Project: New Joplin Library
Site Civil/Landscape Construction Documents
Volume 2 of 2

Client: City of Joplin

ADDENDUM NO. 2

UPDATED DRAWINGS – ADDENDUM #2 LANDSCAPE

Site General Information

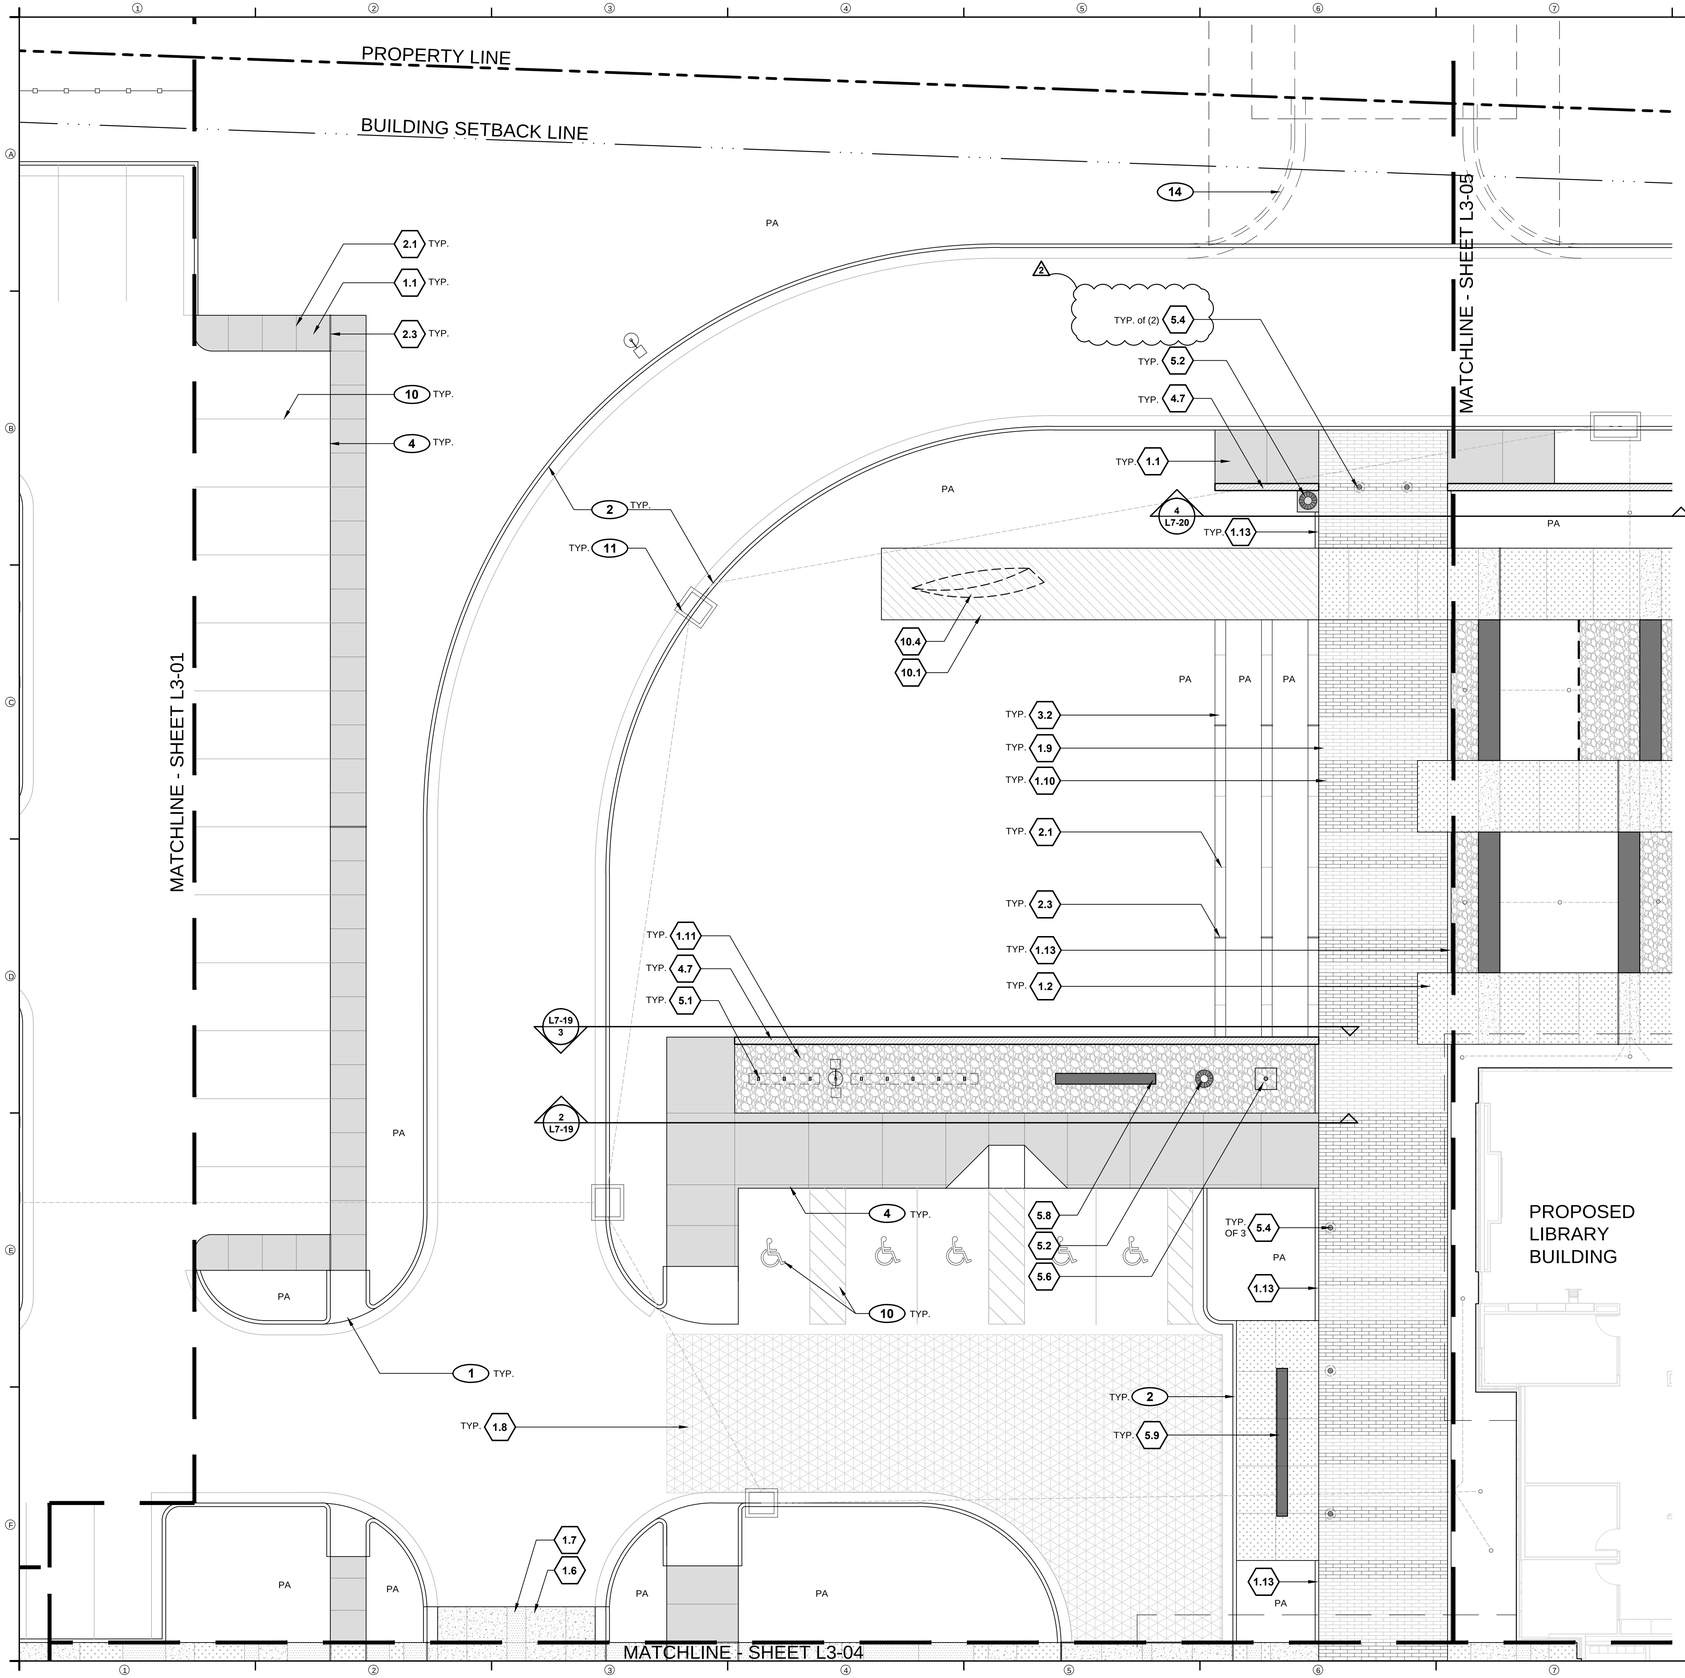
Sheet L0-04: Modified Plant List Schedule Abbreviations to correspond with drawing updates on sheets L9-01 to L9-08

SITE MATERIALS PLAN

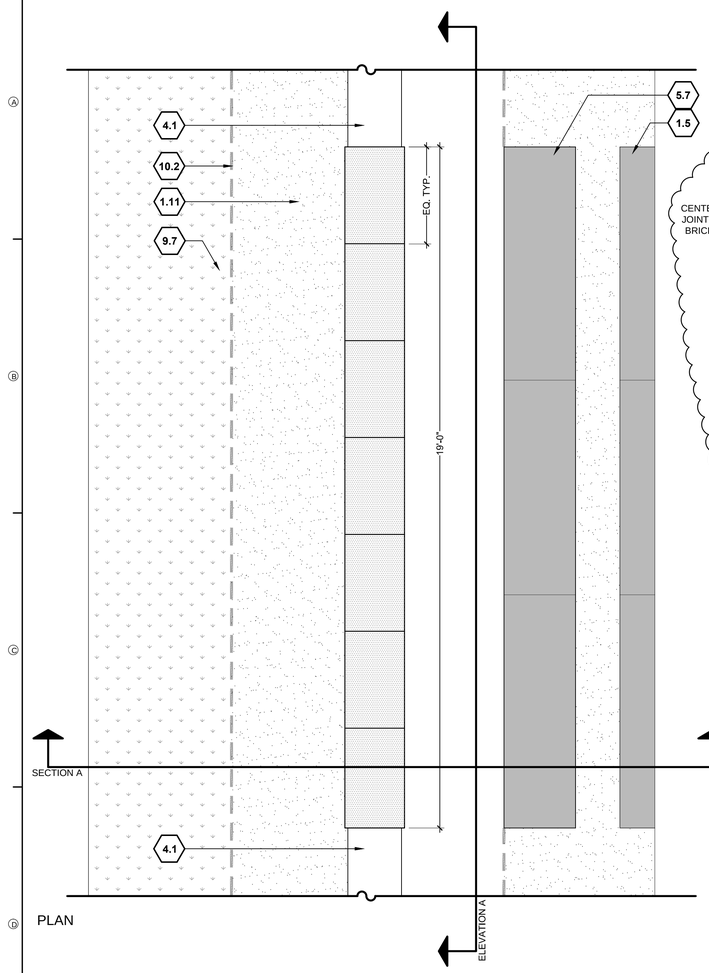
1) Plan sheet L3-03 shows two Bollards (Type 3 - Non-Lighted Structural Core) at the east end of the sidewalk. Plan sheet ME101 shows these two bollards to be powered (LP1-24, LC5). Are these supposed to be lighted bollards (Type 2 – Lighted Structural Core)?

Sheet L3-03: Site keynotes 5.5 at top of drawing was changed to 5.4 to represent two additional lighted bollards. A total of 14 total lighted bollards are in the project.

L7-06

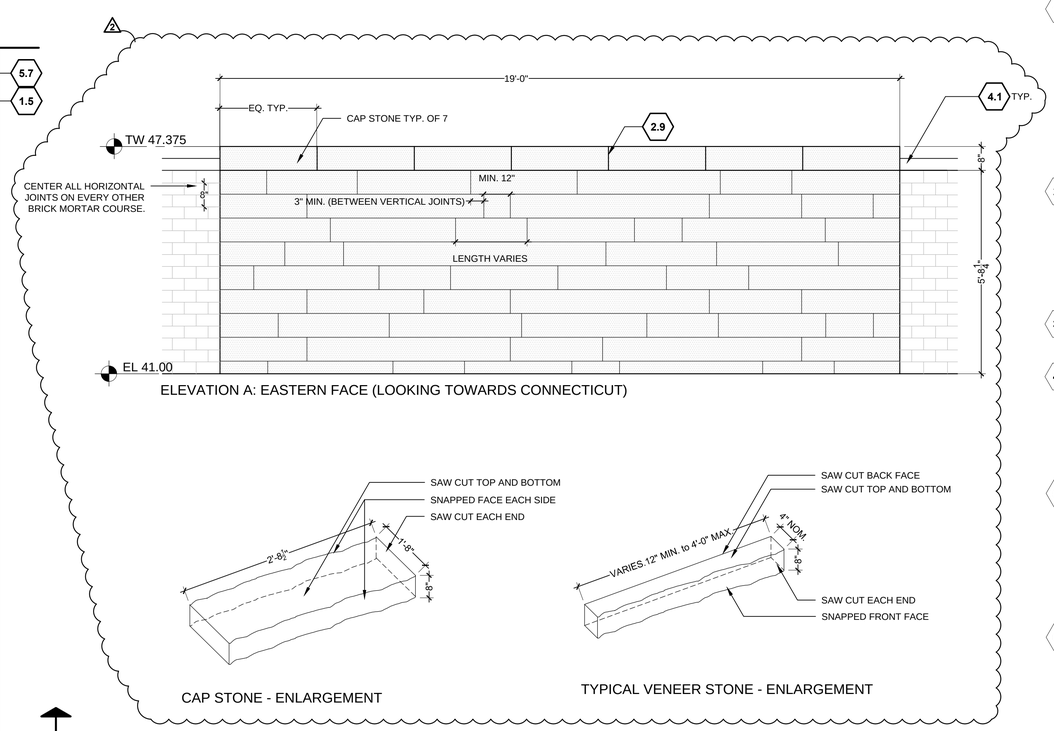
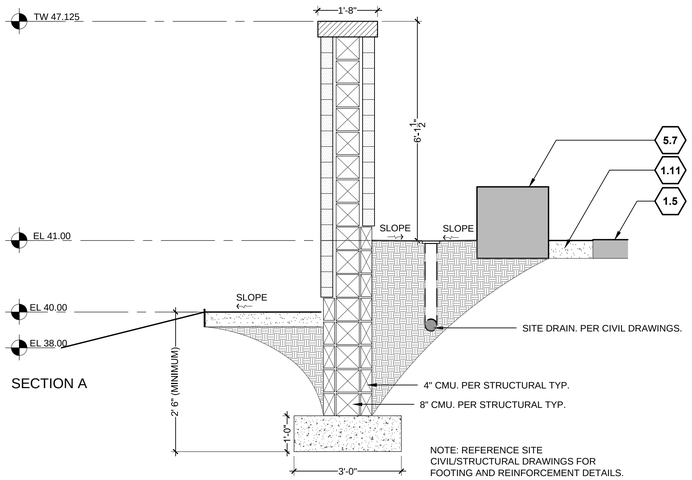
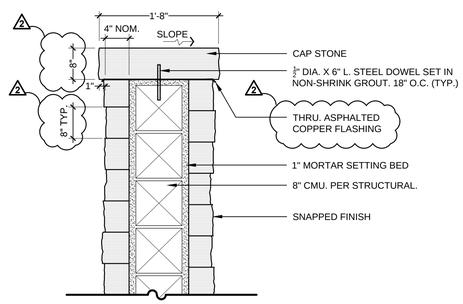
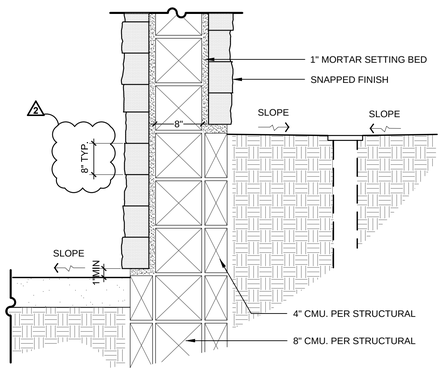
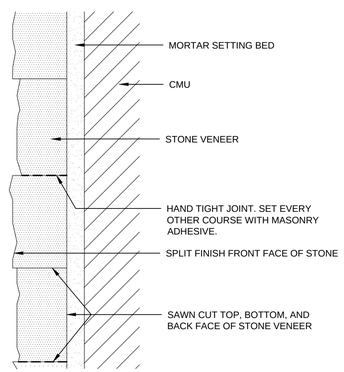
Sheet L7-06: Stone Coursing was changed to 8" in dimension to match the Architectural brick dimensionality, to align with every second course correctly.

Asphalted Copper Flashing was added at top of wall.

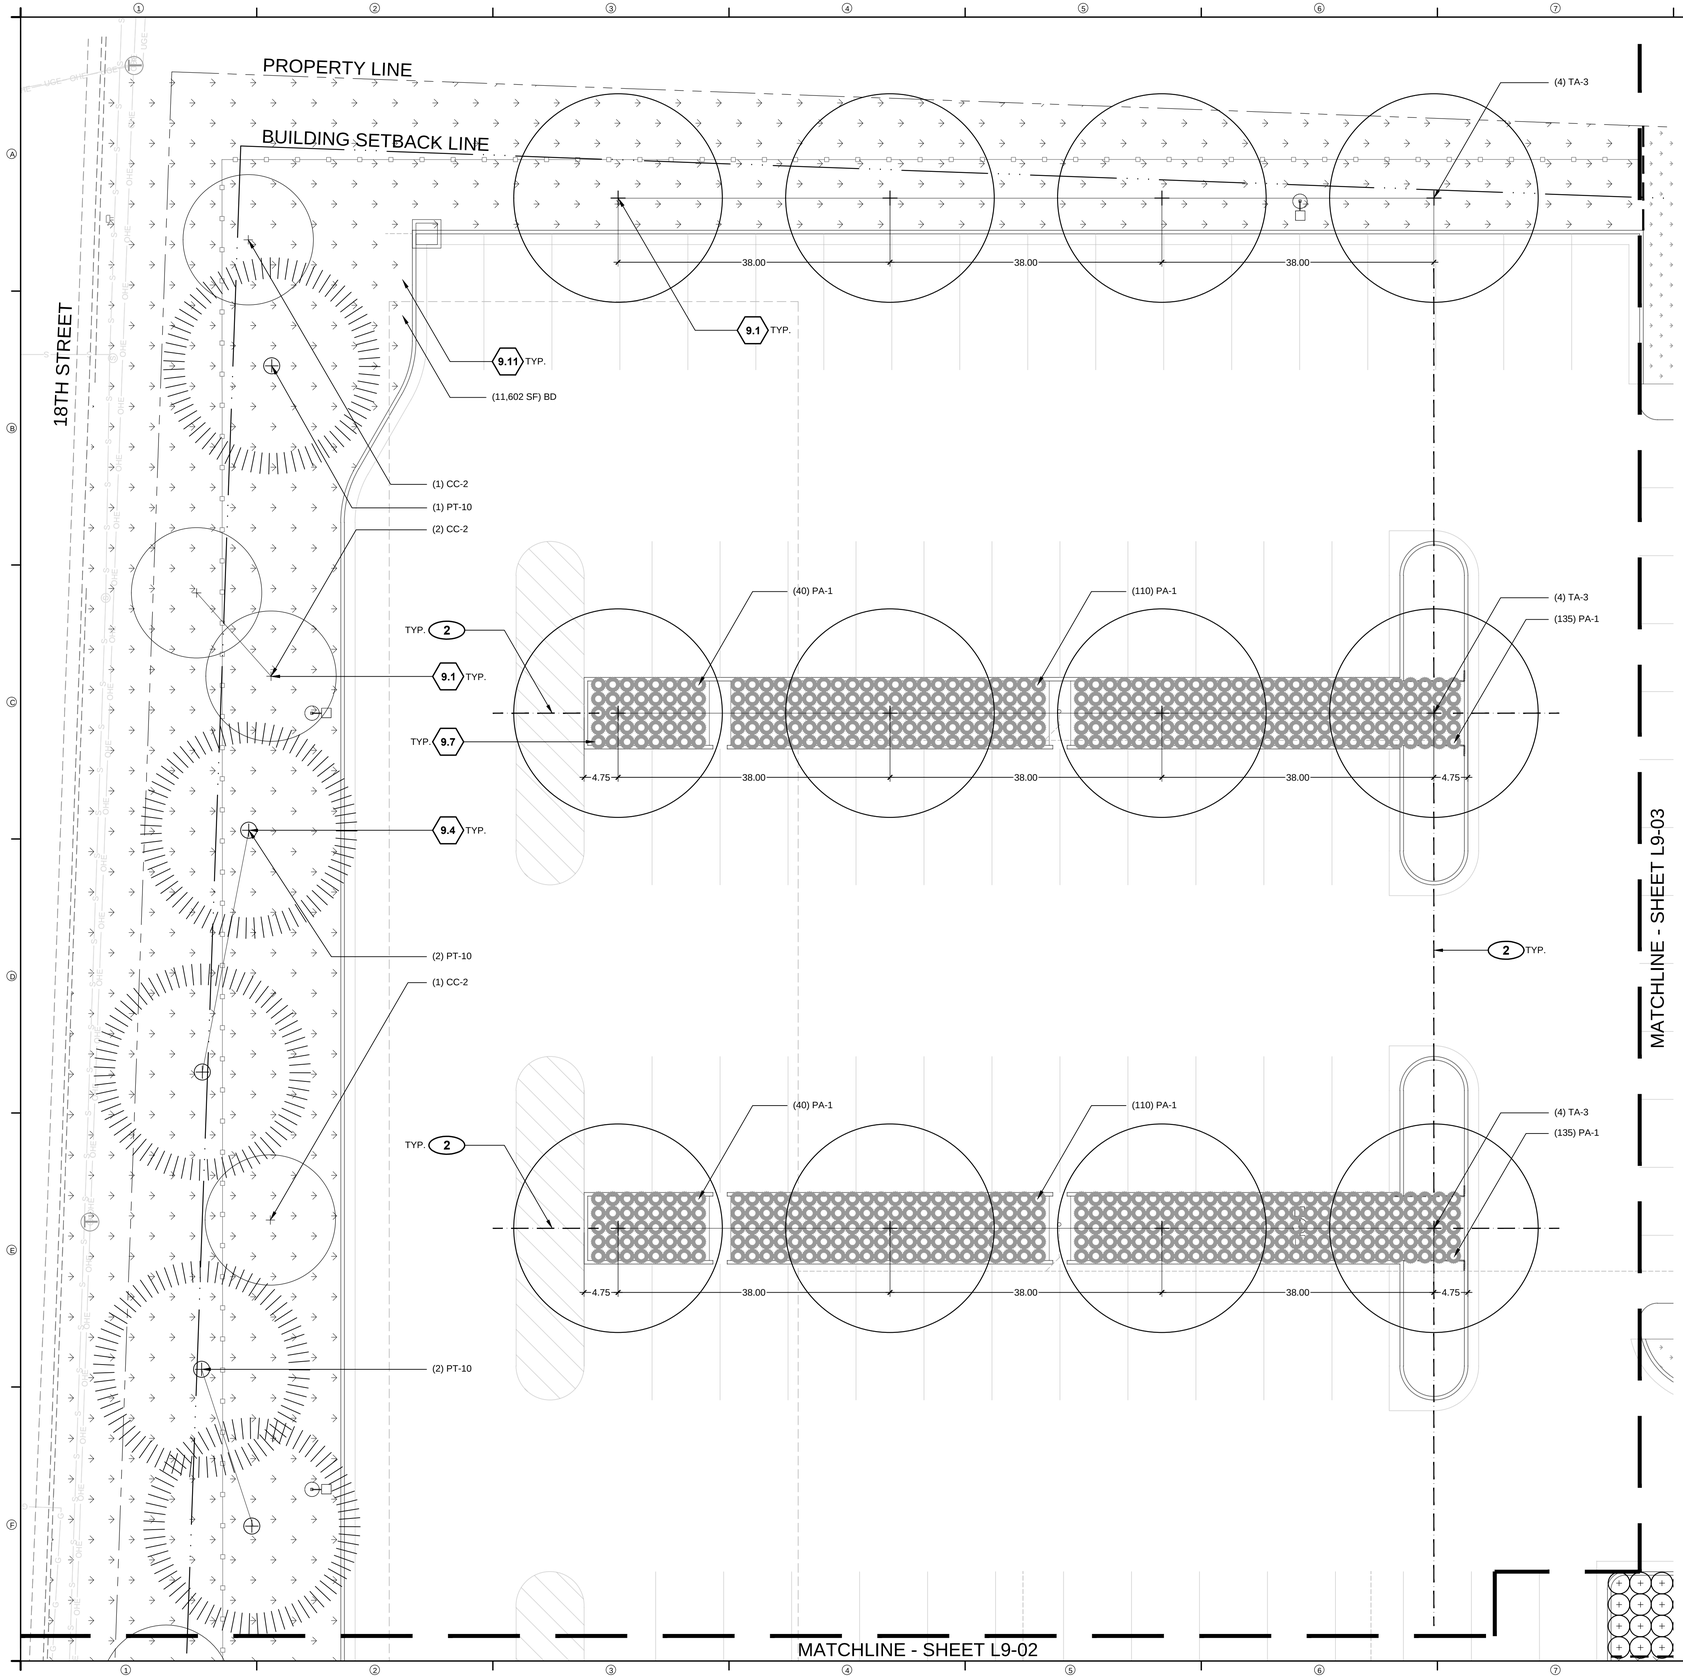
Sheet L7-07: Stone joint was changed in section A to a mitered cut

SITE PLANTING PLAN

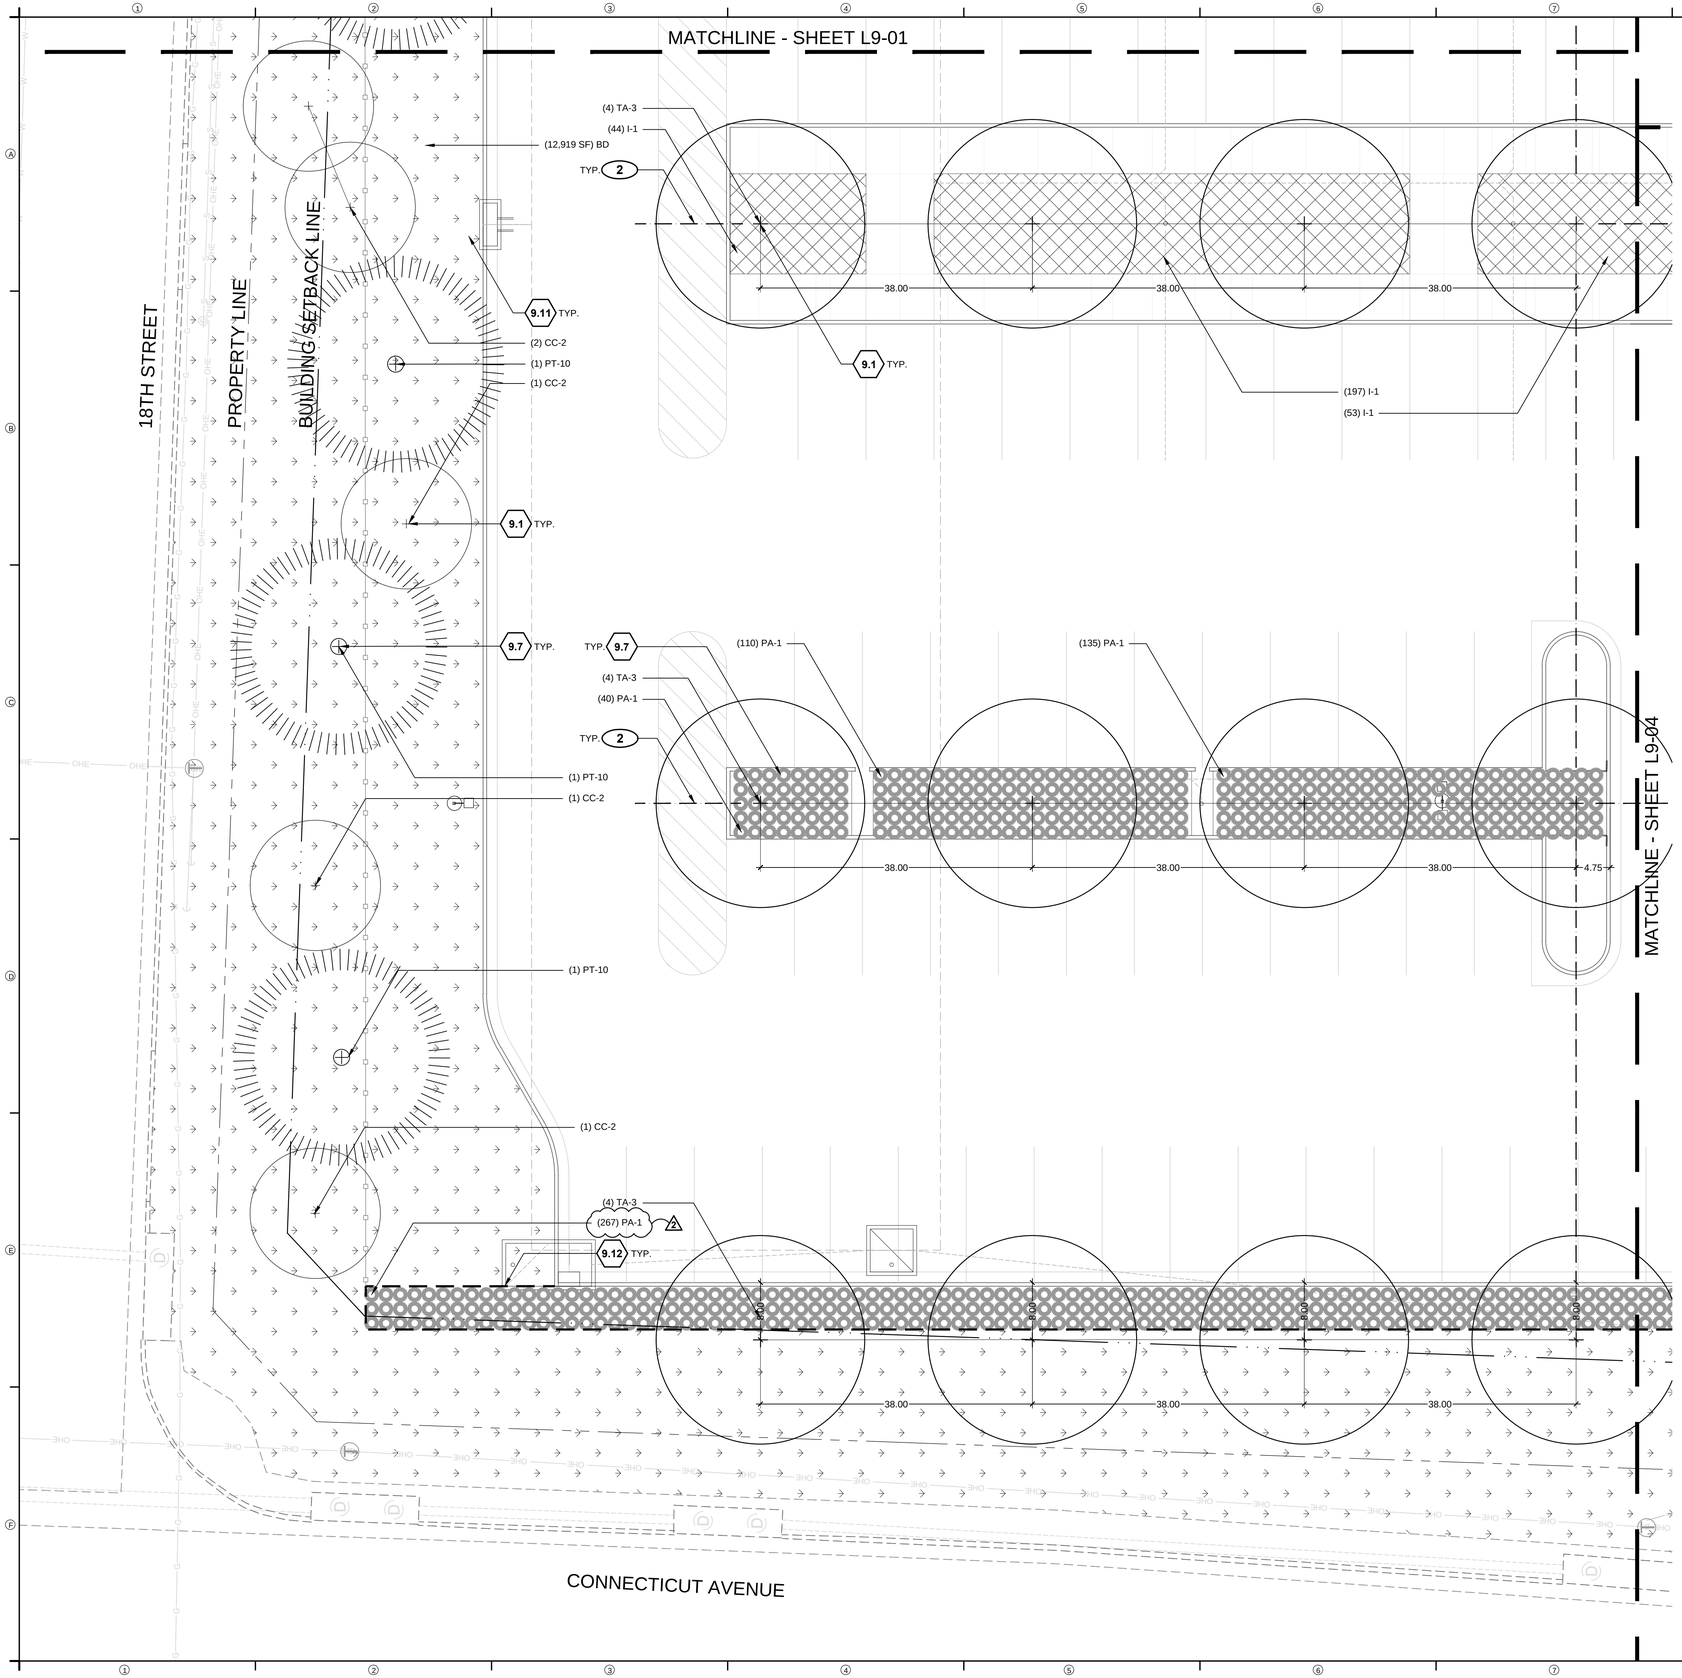
1. Sheet L9-01
a. plan notes a PA-1, legend notes a PA-1 plant type under both Ornamental grasses and Perennials. Which PA-1 is to be used on this sheet?

Sheet L9-01: The Legend has been updated for all sheets to reflect the perennial PA-1 to now be PAF-1.

This is the Ornamental Grass on this sheet. The Legend has been updated for all sheets to reflect the perennial PA-1 to now be PAF-1.
